## STM32F030x4/x6/x8/xC device errata

This document applies to the part numbers of STM32F030x4/x6/x8/xC devices and the device variants as stated in this page. It gives a summary and a description of the device errata, with respect to the device datasheet and reference manual RM0360. Deviation of the real device behavior from the intended device behavior is considered to be a device limitation. Deviation of the description in the reference manual or the datasheet from the intended device behavior is considered to be a documentation erratum. The term “errata” applies both to limitations and documentation errata.

Figure 1. Masked RTC interrupt

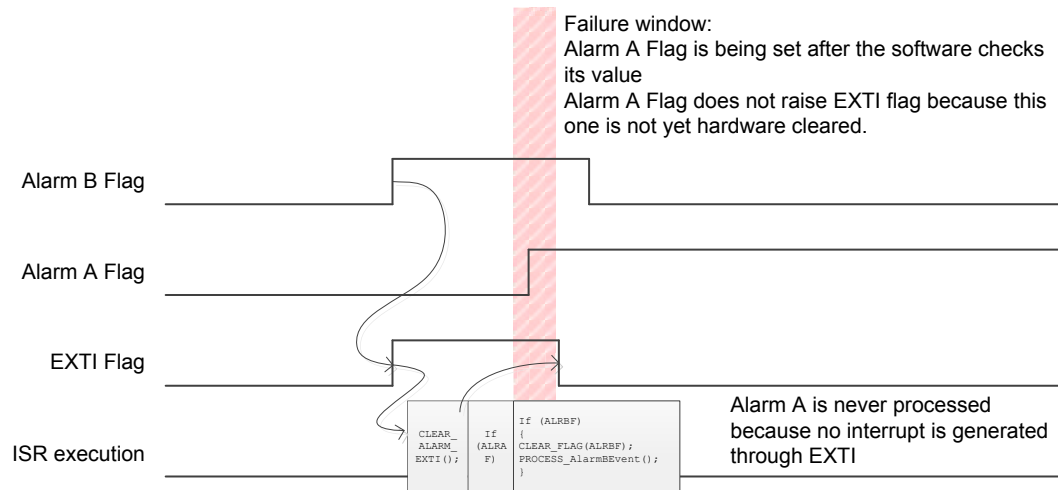
One RTC interrupt request can mask another RTC interrupt request if they share the same EXTI configurable line. For example, interrupt requests from Alarm A and Alarm B or those from tamper and timestamp events are OR-ed to the same EXTI line (refer to the *EXTI line connections* table in the *Extended interrupt and event controller (EXTI)* section of the reference manual).

The following code example and figure illustrate the failure mechanism: The Alarm A event is lost (fails to generate interrupt) as it occurs in the failure window, that is, after checking the Alarm A event flag but before the effective clear of the EXTI interrupt flag by hardware. The effective clear of the EXTI interrupt flag is delayed with respect to the software instruction to clear it.

In the interrupt service routine, apply three consecutive event flag checks - source one, source two, and source one again, as in the following code example:

void RTC_Alarm_IRQHandler(void)
{
    CLEAR_ALARM_EXTI(); /* Clear the EXTI's line Flag for RTC Alarm */
    If(ALRAF) /* Check if AlarmA triggered ISR */
    {
        CLEAR_FLAG(ALRAF); /* Clear the AlarmA interrupt pending bit */
        PROCESS_AlarmAEvent(); /* Process AlarmA Event */
    }
    If(ALRBF) /* Check if AlarmB triggered ISR */
    {
        CLEAR_FLAG(ALRBF); /* Clear the AlarmB interrupt pending bit */
        PROCESS_AlarmBEvent(); /* Process AlarmB Event */
    }
    If(ALRAF) /* Check if AlarmA triggered ISR */
    {
        CLEAR_FLAG(ALRAF); /* Clear the AlarmA interrupt pending bit */
        PROCESS_AlarmAEvent(); /* Process AlarmA Event */
    }
}
